CONSTRUCTION PLANS  
FOR  
**THE RIDGE AT LORSON RANCH FILING NO. 1**  
STREET & STORM SEWER CONSTRUCTION PLANS

THE RIDGE AT LORSON RANCH FIL NO. 1  
STREET / STORM SEWER  
CONSTRUCTION PLANS

DATE: NOV, 2021  
PROJECT NO: 100.066  
SHEET NUMBER: C0.1  
TOTAL SHEETS: 49

DATE: NOV, 2021  
 PROJECT NO. 100.066  
 SHEET NUMBER C6.57  
 TOTAL SHEETS: 49

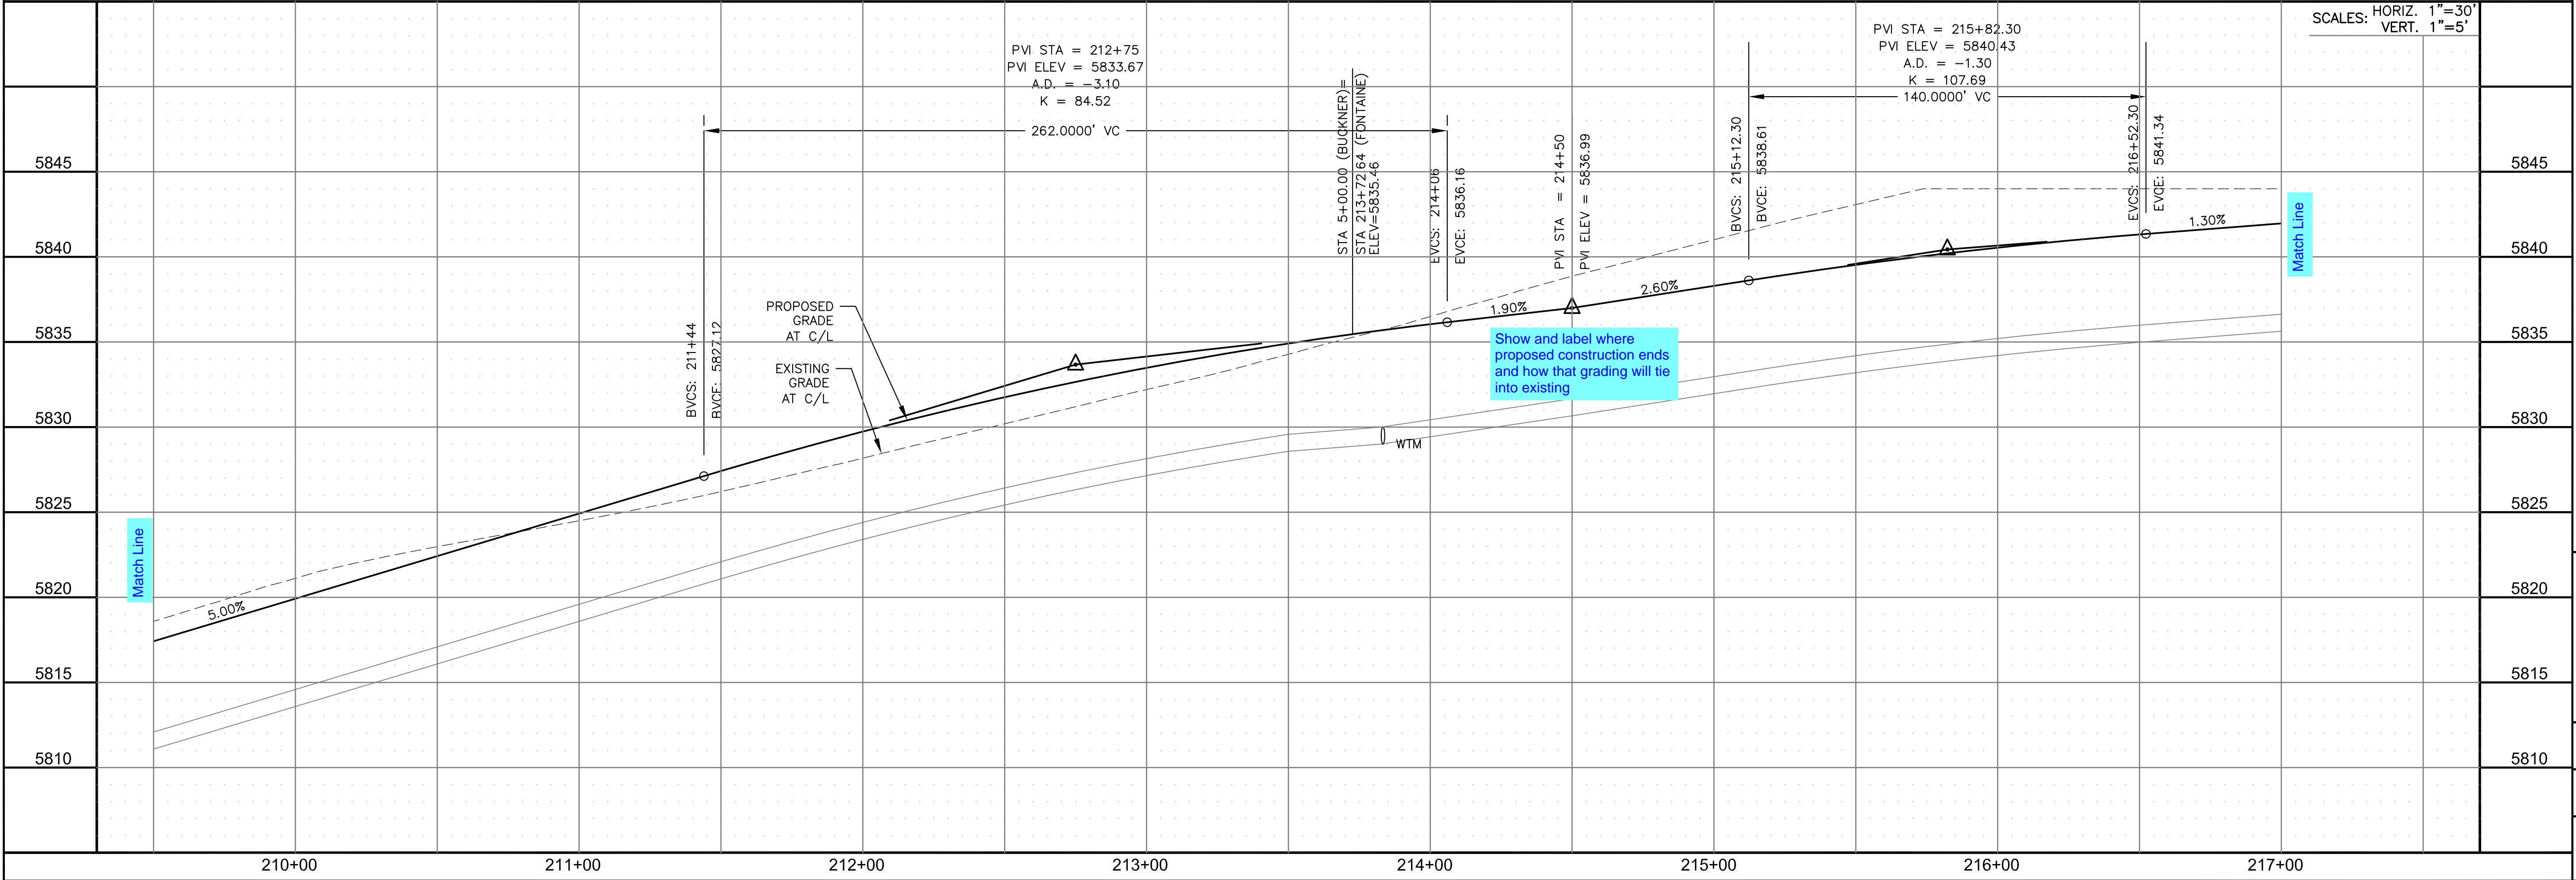
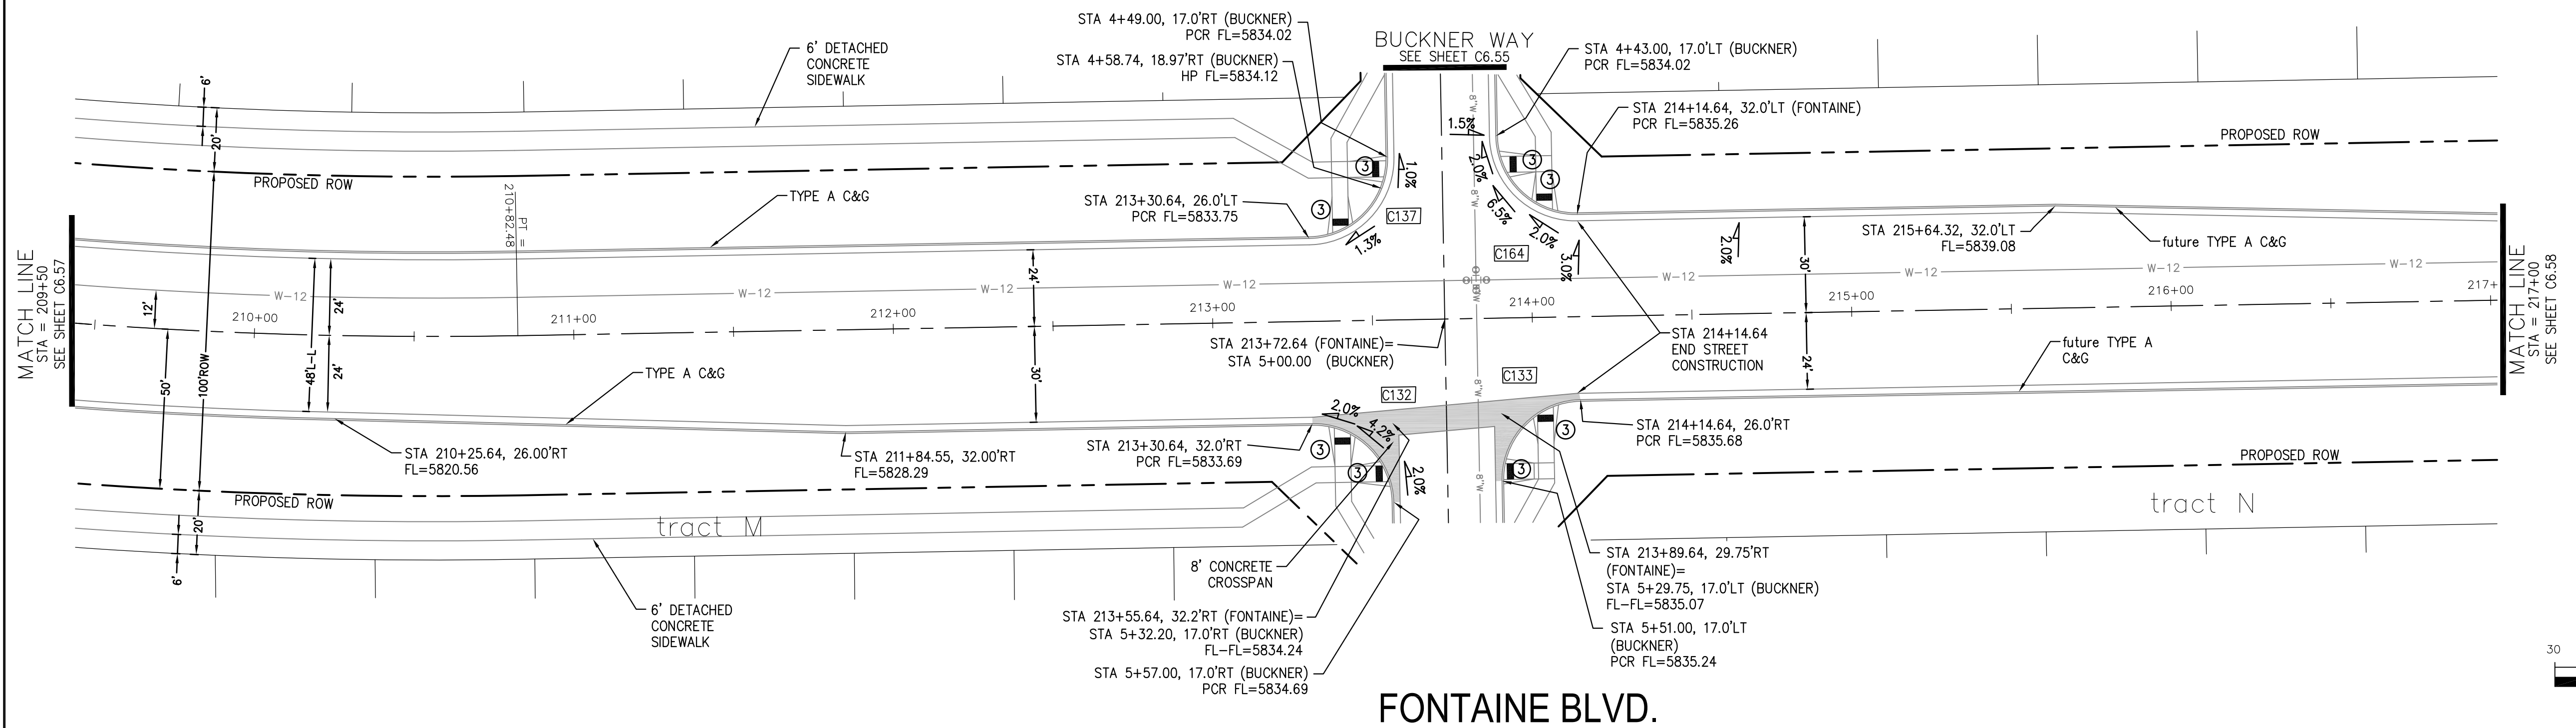
Show and label where proposed construction ends and how that grading will tie into existing
